Amendments to the Drawings:

Title: SYSTEM AND METHOD OF CONTROLLING V-BELT TYPE CONTINUOUSLY VARIABLE TRANSMISSION

Inventor(s): Masahiro YAMAMOTO et al.
Appl. No.: 10/674,818

FIG.2

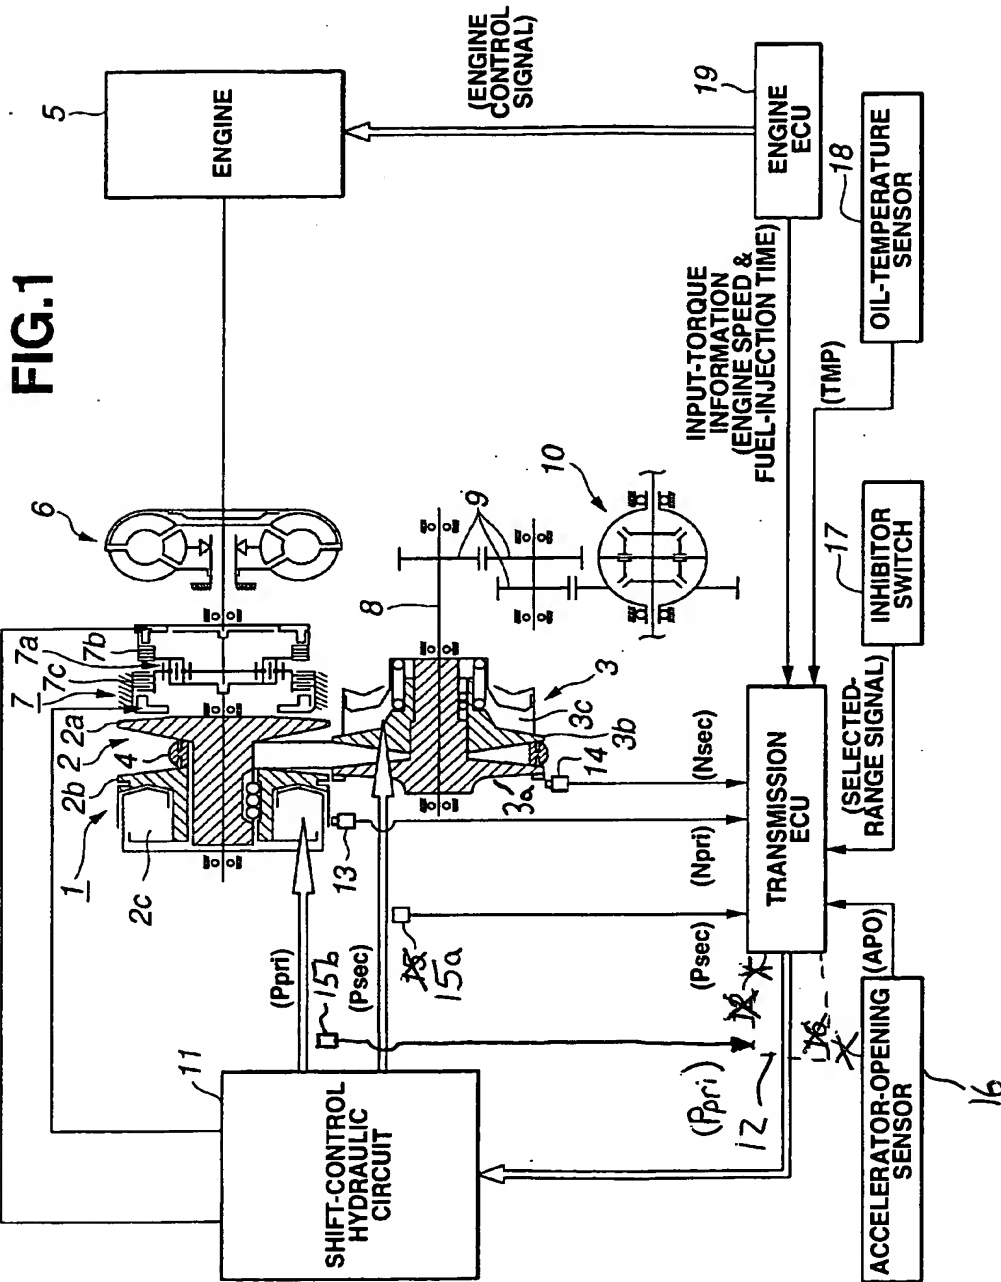
The specific change which has been made to Figure 2, is "15" has been changed to "15a."

FIG.4

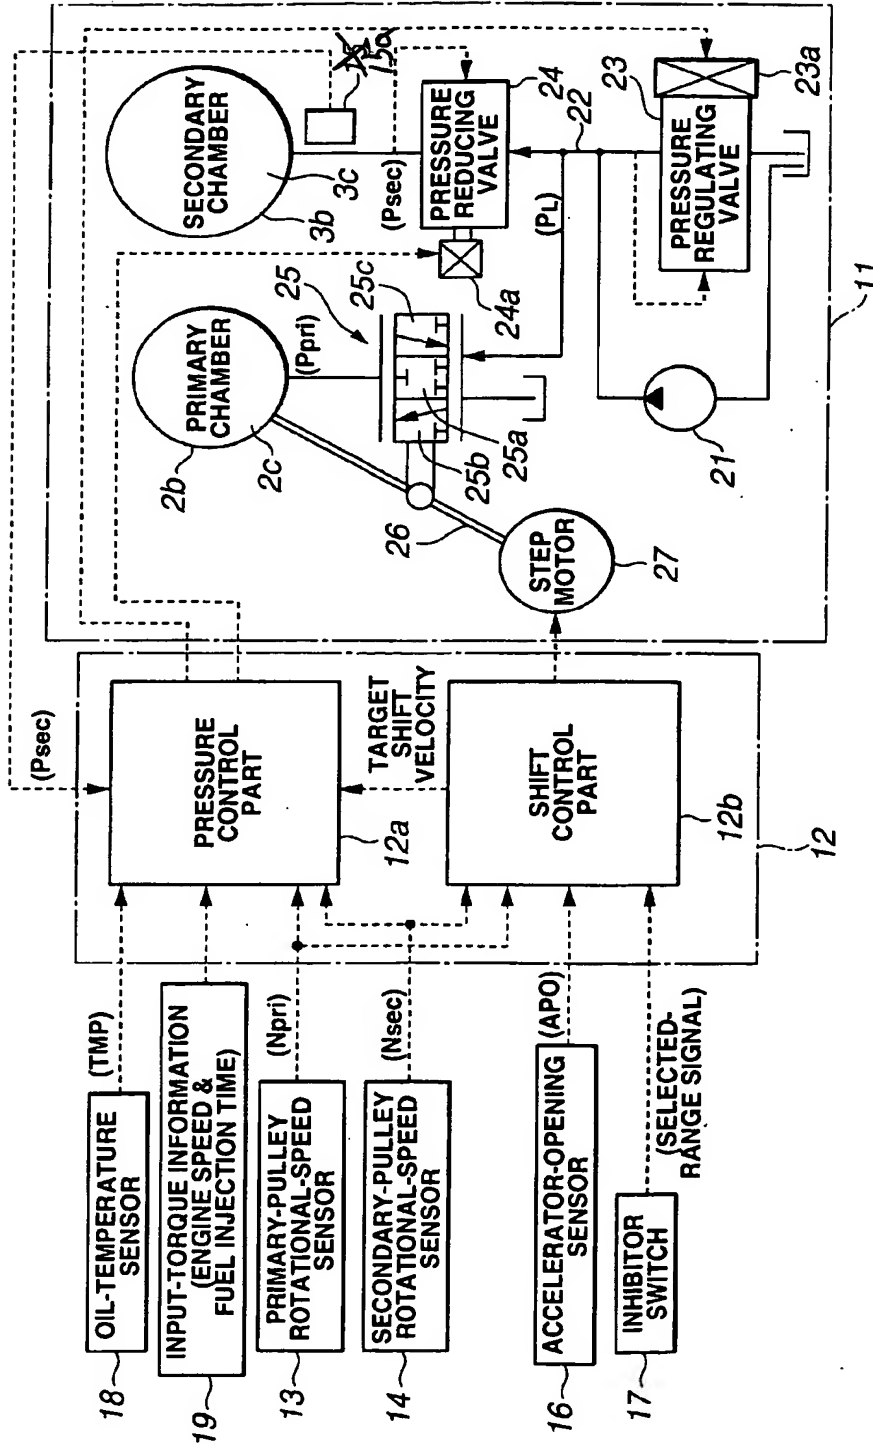
The specific change, which has been made to Figure 4, is "HIGT" has been changed to "HIGH."
